Heckington Fen Solar Park

EN010123

Applicant Response to the Examining Authority's Second Written Questions

Document Reference: ExA.ResponsesSWQ-D4.V1

Appendix 1- Screened Zone of Theoretical Visibility and Viewpoint Location Plan- Kyme Tower

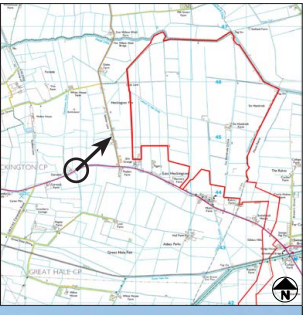
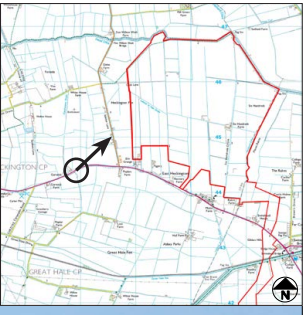
ExA Question Number:	Question Addressed to:	Question	Applicant's Response
HE 2.1	<p>North Kesteven District Council</p> <p>Historic England</p> <p>Applicant</p>	<p>NKDC [REP2-101] and Historic England [REP2-091] consider that the solar park site lies within the setting of the Grade I listed Kyme Tower and that harm would arise to its setting (at the lower end of the scale).</p> <p>A plan [REP3-041] has been provided for the ExA to carry out a further Unaccompanied Site Inspection in order to assist in assessing the setting of Kyme Tower. Paragraphs 10.5.17 to 10.5.21 of ES Chapter 10 [REP2-024] sets out the elements which the Applicant considers contribute to its significance and goes onto conclude that no harm is predicted to occur. The Applicant's summary of ISH4 Agenda item 4 a) [REP3-039] reiterates their position regarding intervisibility and significance, and offers to provide further information in the form of visualisations.</p> <p>Could NKDC and Historic England:</p> <p>i) Clarify whether the level of detail provided in paragraphs 10.5.17 to 10.5.21 of ES Chapter 10 [REP2-024] is proportionate to the importance of the heritage asset and if it is sufficient to</p>	<p>A Screened Zone of Theoretical Visibility (sZTV) and Viewpoint Location Plan- Kyme Tower have been prepared from the base of Kyme Tower, i.e. at ground level, to illustrate the lack of visibility of the Energy Park in what the Applicant considers to be the key close-ranging views of Kyme Tower (i.e. where/how the asset is best appreciated). The sZTV is presented at Appendix 1 of this document. Two photomontages have also been prepared (Viewpoint (VP) A and VPB): the first capturing a close-ranging view and the second a longer-ranging view of the asset. The photomontages are presented at Appendix 2 of this document.</p> <p>The sZTV is LiDAR based (Light Detection and Ranging), combining the Digital Terrain Model (DTM) and Digital Surface Model (DSM) to derive screening features. This method of sZTV takes into account the varied heights of screening features as derived from historic LiDAR surveys, and is therefore representative of the time of survey for that area. Any changes in vegetation cover or building addition/removal will not be taken into account after this date. Vegetation is considered to be a continuous block from canopy to ground, creating solid screening features, it does not consider tree trunks. In reality, vegetation may have gaps, particularly vegetation that experiences leaf drop. Filtered views are not considered, therefore site photography has been used to verify sZTV outputs which illustrate a theoretical extent of visibility. The sZTV has also raised the ground level within the Energy Park by 3m or 3.5m (according to the Proposed Development layout) to model the scenario of the scheme being built out.</p> <p>The sZTV illustrates the land visible (yellow shading) to a 1.7m tall observer standing at ground level on the public road and within the</p>

ExA Question Number:	Question Addressed to:	Question	Applicant's Response
		<p>understand the potential impact of the proposal on its significance.</p> <p>ii) Confirm whether they agree with the elements of setting in paragraph 10.5.17 of ES Chapter 10 and state if there are any additional elements they also consider contribute to its significance.</p> <p>iii) Provide any further comments they may have in relation to the Applicant's summary of ISH4 Agenda item 4 a) [REP3-O39] in relation to Kyme Tower.</p> <p>Could the Applicant:</p> <p>i) Provide visualisations towards/from Kyme Tower to assist the ExA in their assessment of its setting.</p>	<p>grassed area of Kyme Tower (black hatching). It indicates that the Tower itself is visible (as expected) and also the adjoining land to the north and east. It further indicates that vegetation screens the outlying land to the east and south-east and creates heavily filtered views out to the west and south-west. This suggests that there will be very limited to no visibility of the Energy Park from ground level within the curtilage of Kyme Tower.</p> <p>This is further supported by the VPB photomontage, which captures a key view of Kyme Tower from the public road skirting the northern edge of the grassed area. It further illustrates that there would only be the very smallest glimpse of the Energy Park from this location on account of intervening built form and vegetation. Such limited visibility of the Proposed Development will not compromise the ability to, or otherwise adversely affect the, experience of Kyme Tower from within its curtilage.</p> <p>VPA is located within a layby on the A17 that affords a long-ranging view of Kyme Tower with peripheral co-visibility of the Energy Park. The photomontage is realigned from RVAA Viewpoint 5 (Figure 7.3-Photomontages Part 2, 6.2.7/APP-150). It demonstrates that components of the Energy Park would be obliquely co-visible with Kyme Tower from this location. However, the visible infrastructure would comprise only a small portion of the panorama and be seen in the context of the modern housing on Sidebar Lane. Such limited visibility of the Proposed Development will not compromise the ability to, or otherwise adversely affect the experience of Kyme Tower from the A17.</p> <p>It was not possible to produce a photomontage to assess outward views from the top of the Tower. There are health and safety issues in accessing the parapet via the external stair turret (the main</p>

ExA Question Number:	Question Addressed to:	Question	Applicant's Response
			staircase and floors of the tower have been removed). Also, the Tower is not open to the public, although it is noted that Historic England's <i>GPA3</i> states that contribution of setting to heritage significance does not depend on there being public rights or ability to access the asset.
HE 2.2	Lincolnshire County Council North Kesteven District Council	The D3 update to the outline CEMP [REP3-019] at paragraphs 7.71 to 7.75 includes provision for protection zones and historic building record of non-designated heritage assets. Could NKDC and LCC confirm if they are satisfied with this approach.	
HE 2.3	Lincolnshire County Council North Kesteven District Council Boston Borough Council	R6 (2) of the draft DCO (REP3-004] includes an additional criteria regarding the need for design details to take account of the results of archaeological investigations. Could LCC, NKDC and BBC confirm their agreement to the proposed additional wording.

FIGURE 6.2 Landscape Strategy Plan

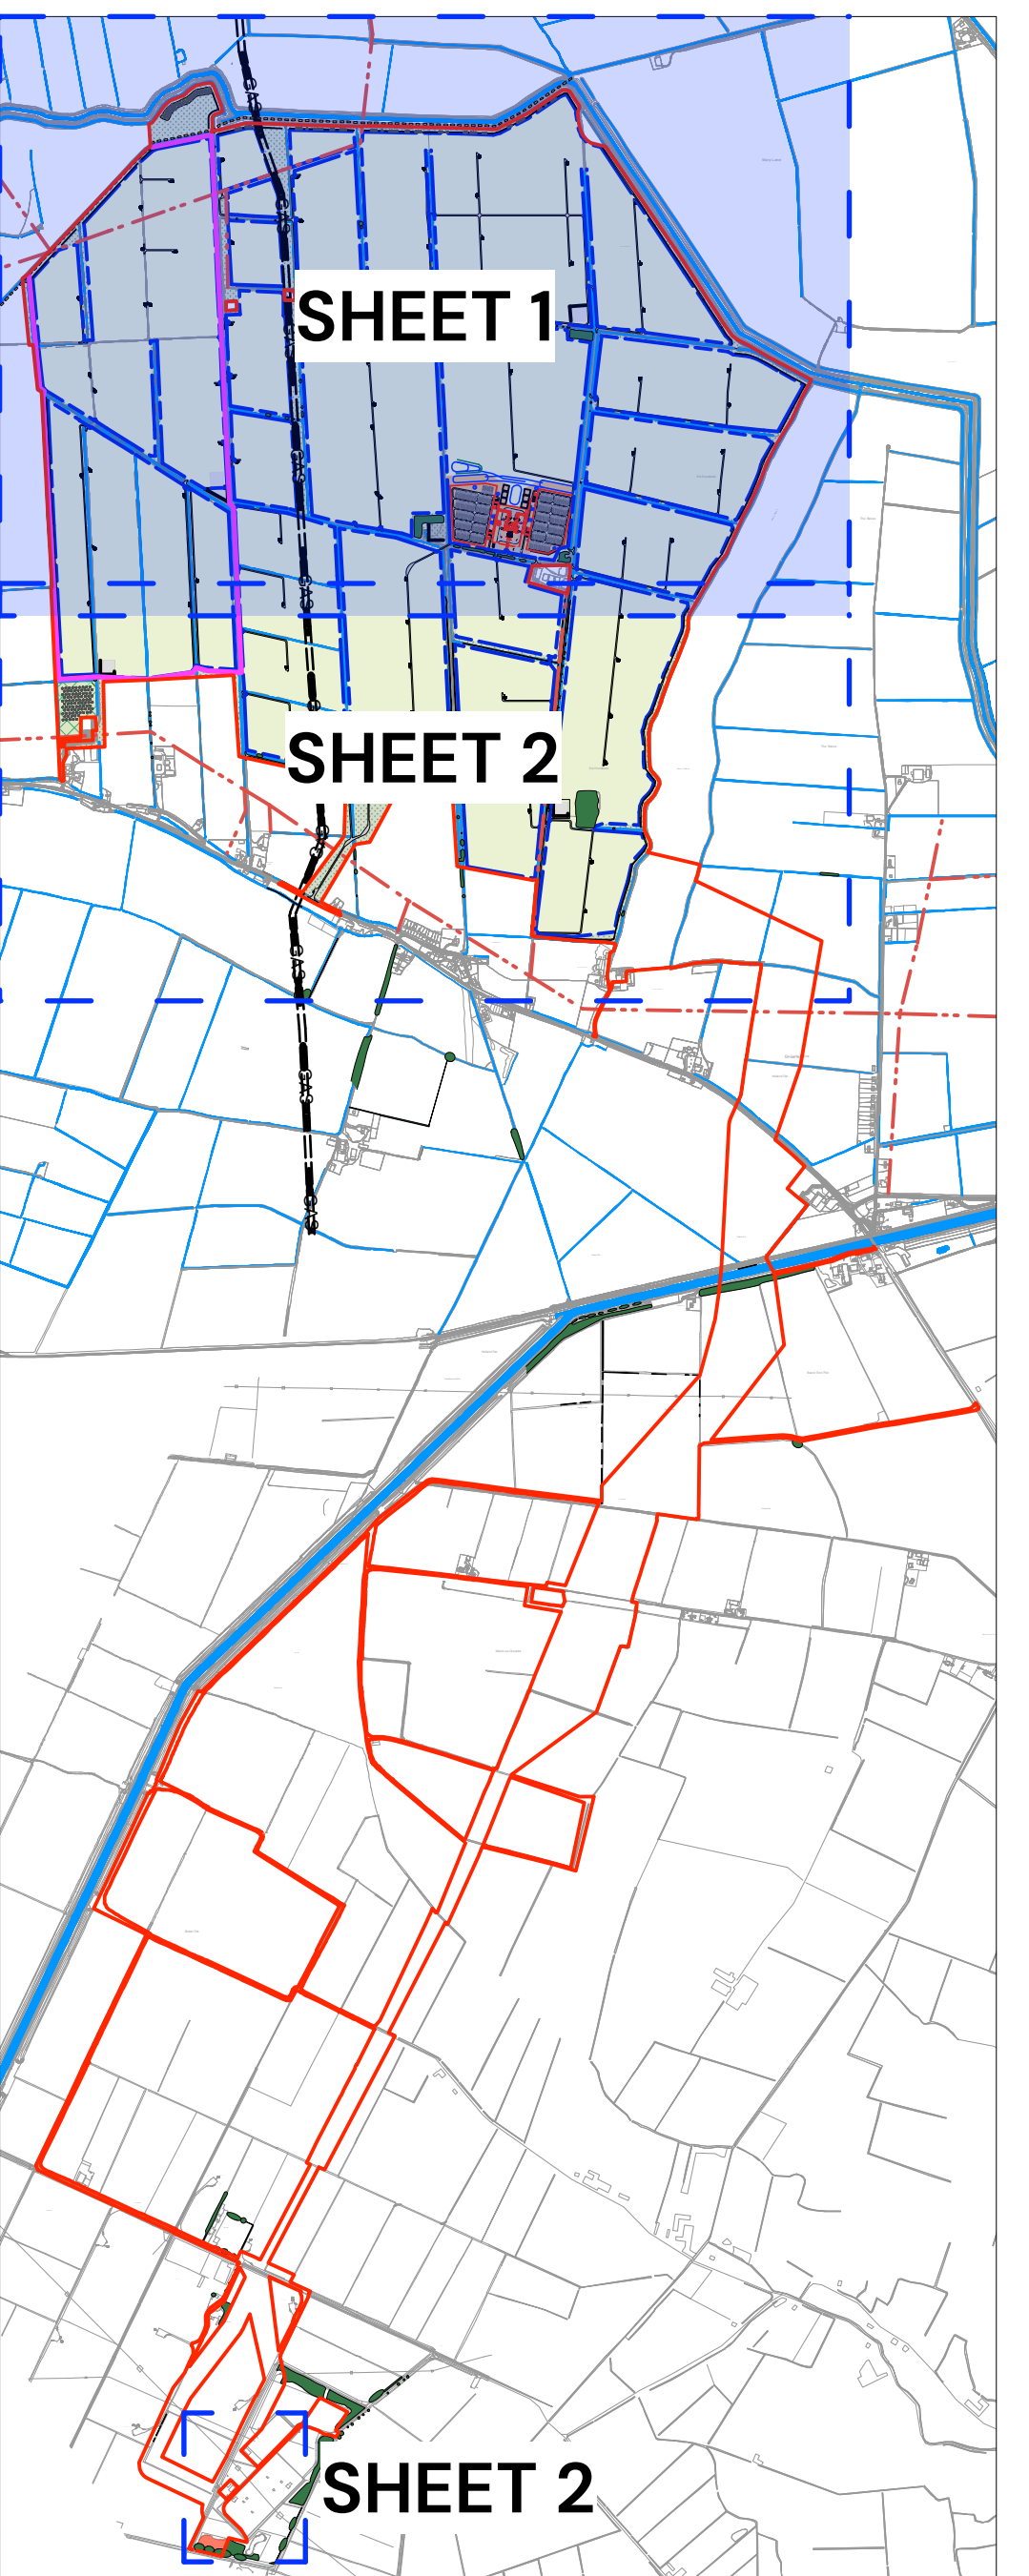
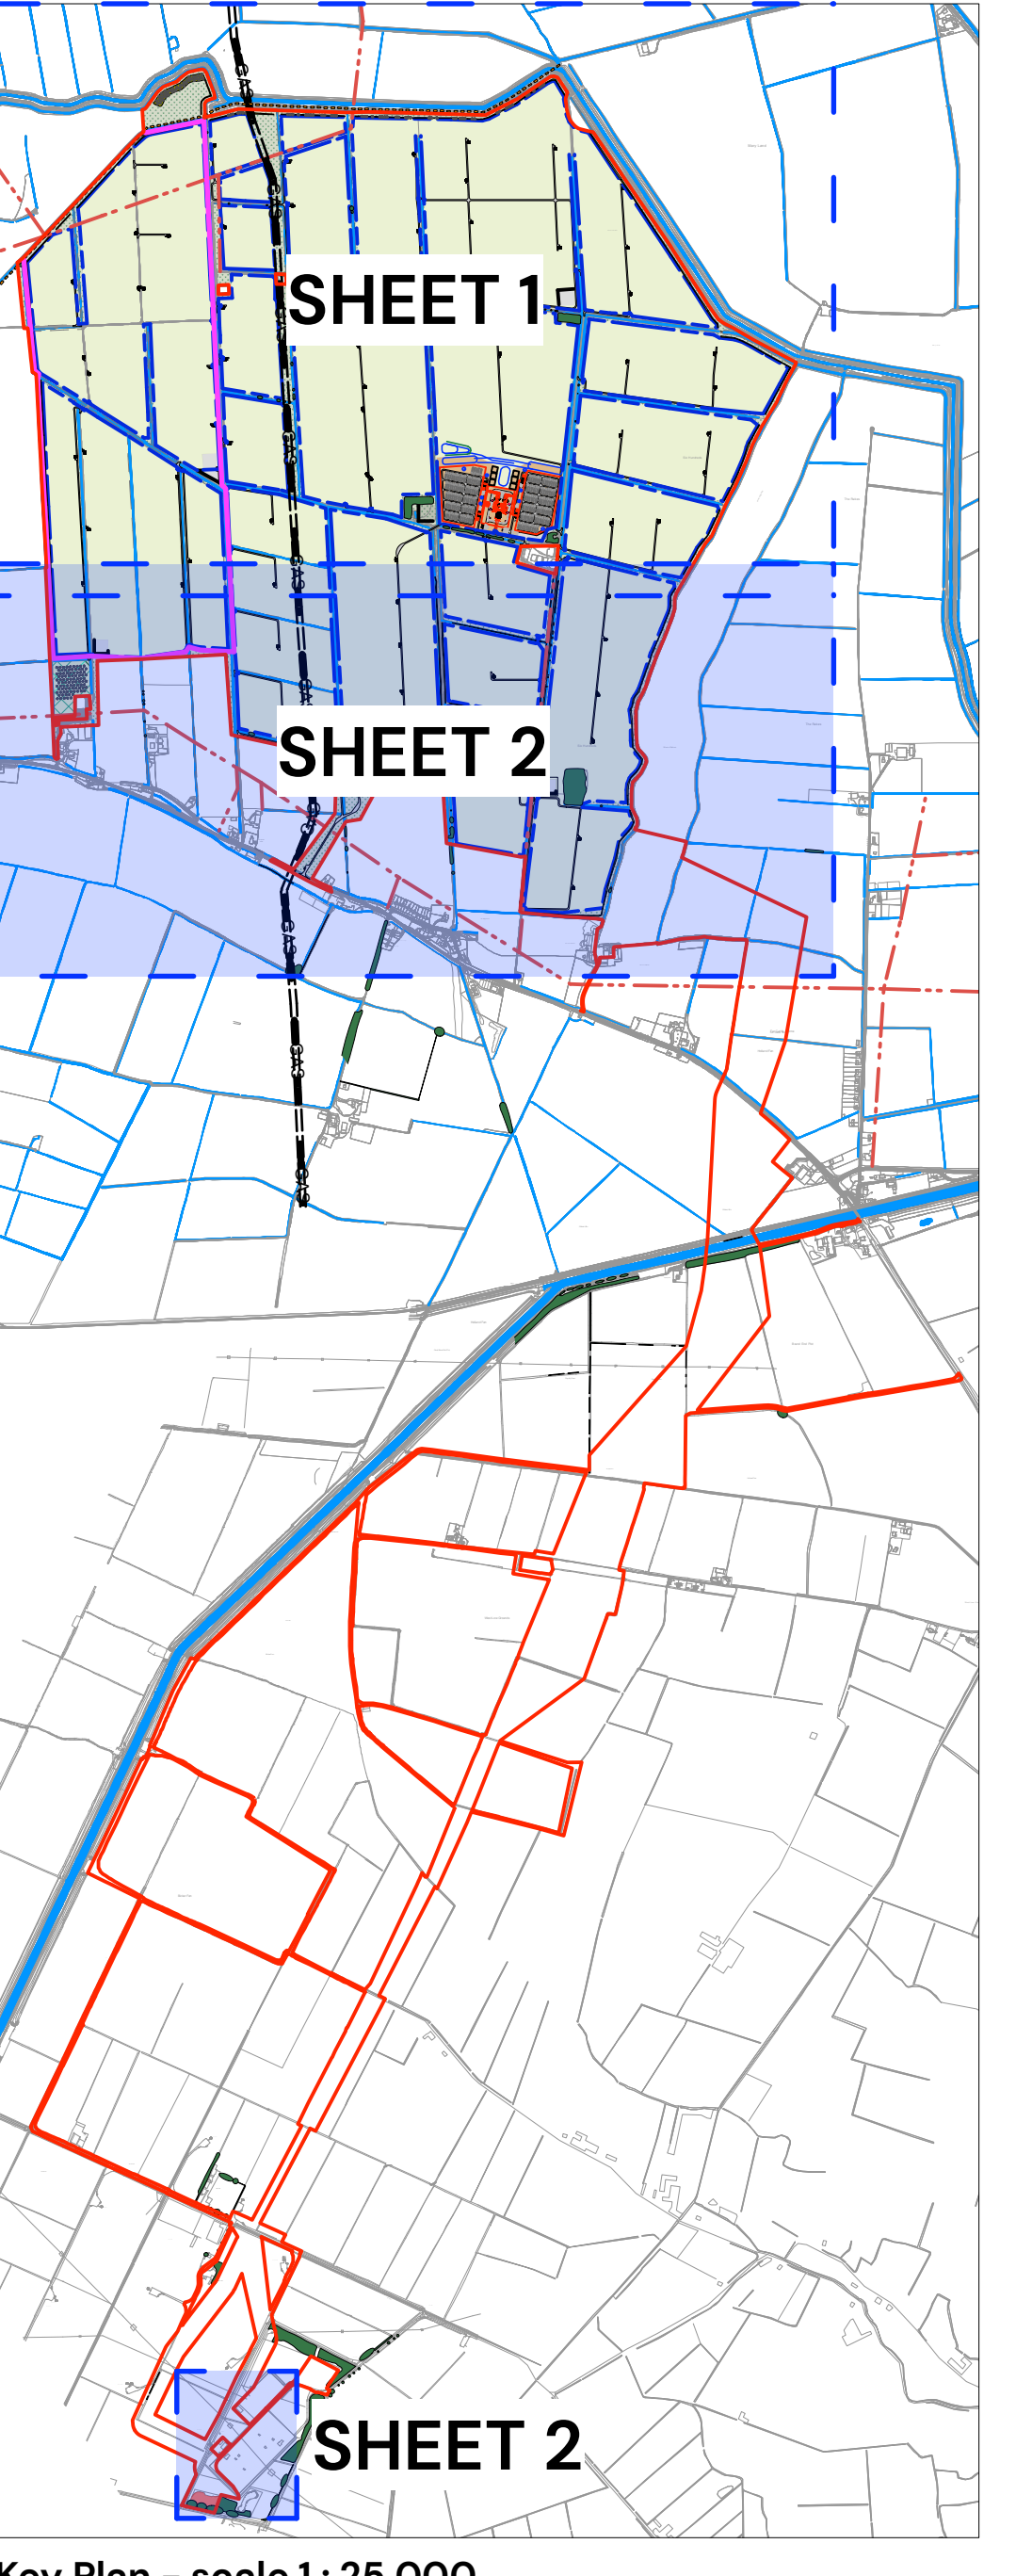
ExA Question Number:	Question Addressed to:	Question	Applicant's Response
		paragraphs 7.33 to 7.37 of the outline CEMP.	
BIO 2.9	Applicant	<p>The D3 cover letter [REP3-001] part 6 indicates a change to the minimum height of transplanted trees from a minimum of 2.5m to 1.5m.</p> <p>Could the Applicant:</p> <p>i) Indicate where the amended height is shown in the submitted plans/documents.</p> <p>ii) Further explain the reasons for this change.</p> <p>iii) Indicate any implications for the ES.</p>	<p>i) The amended minimum height of transplanted trees from 2.5m to 1.5m is indicated within the planting schedule tables on drawing P20-2370_76P Landscape Strategy Plan, sheet 2 (document reference: 6.2.6 / REP3-012). This location is further clarified within Appendix 3 of this document by means of a red revision cloud.</p> <p>ii) The Applicant confirms that a number of plant nurseries have been contacted, which confirmed that trees at such height (of 2.5m) are difficult to procure and it is not certain that they will be available. The Applicant was advised that trees at 1.5m height are more readily available, hence the proposed change.</p> <p>iii) The Applicant has considered the implication of having lower tree stock planted at Year 1 and wishes to confirm that the assessment of residual effects presented in Chapter 6 (document reference 6.1.6/ PS-059) remains valid. Based on the estimated growth rate 0.5m / year for hedgerow vegetation – paragraph 6.3.63 of Chapter 6 (document reference 6.1.6/ PS-059), it is considered that similar growth rate would be applicable to the proposed tree vegetation. On that basis, it is anticipated that at Year 5 the maturing tree canopies would be approximately 4m high. The residual effects rely on the fact that the maturing canopies have grown</p>

ExA Question Number:	Question Addressed to:	Question	Applicant's Response
			and became sufficiently dense to provide a sense of physical and visual enclosure.
BIO 2.10	Applicant	<p>The outline LEMP [REP3-021] includes a schedule of management of maintenance.</p> <p>Could the Applicant explain the amendment to hedgerow cutting with section 6, ref 6.1.7 (Schedule of Management of Maintenance, establishment years 0-5) which has amended the height of site boundary hedgerows from 'a minimum' to 'an approximate' height of 5m.</p>	<p>The Applicant wishes to confirm that this change corrects the previously provided information, which was not precise and did not fully reflect the strategy illustrated on Figure 6.2: Landscape Strategy Plan (document reference REP3-012). To confirm, Figure 6.2: Landscape Strategy Plan (document reference REP3-012) refers to hedgerows 'to grow up to and be maintained' at 3m and 3.5m height, and approximately 5m high, managed at maturity. The OLEMP therefore reflects this.</p>
